S E R V I C E N O T E

Agilent 4396B RF Network/Spectrum Analyzer

Serial Numbers: JP1KE00101 / JP1KE00865

Figure 1. AC Inlet Connector

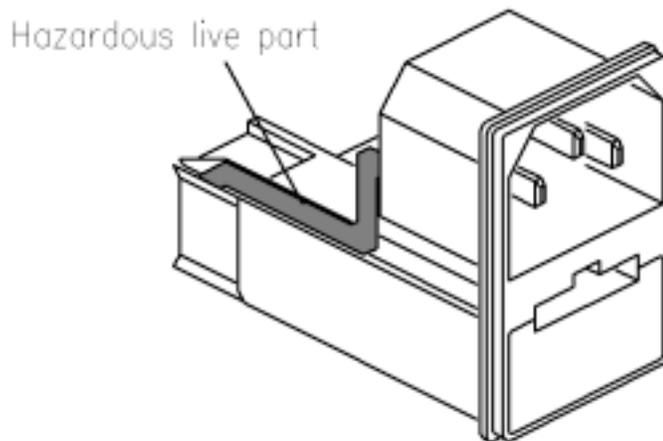
The AC inlet (P/N 1252-6951) has the potential to slip out of the instrument's rear panel slot if the AC power cord is forcefully pulled in a diagonal direction. When this happens, an exposed connection on the AC inlet module may touch the rear panel of the instrument and cause an electrical short if the AC power cord is still connected to the AC power outlet. See Figure 1.

Solution 1. AC Inlet Still Intact.

- Remove the AC power cable from the AC power outlet and the product.
- Remove the top, bottom, and side covers.
- Seal the hot line terminal on the AC inlet with silicon paste (P/N 5183-4112).
- Reinforce the connection between the AC inlet and the rear panel with silicon paste.
- Perform Self Test to verify instrument operation.

Figure 2. Repair Completed Label

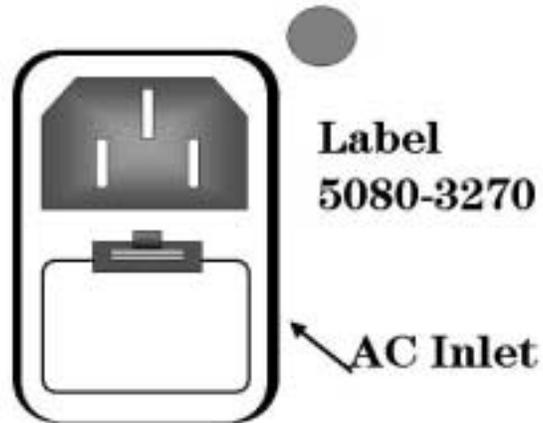
After completing the above instructions, stick the label (P/N 5080-3270) next to the AC Inlet on the rear panel as a mark that this repair has been completed. See Figure 2.
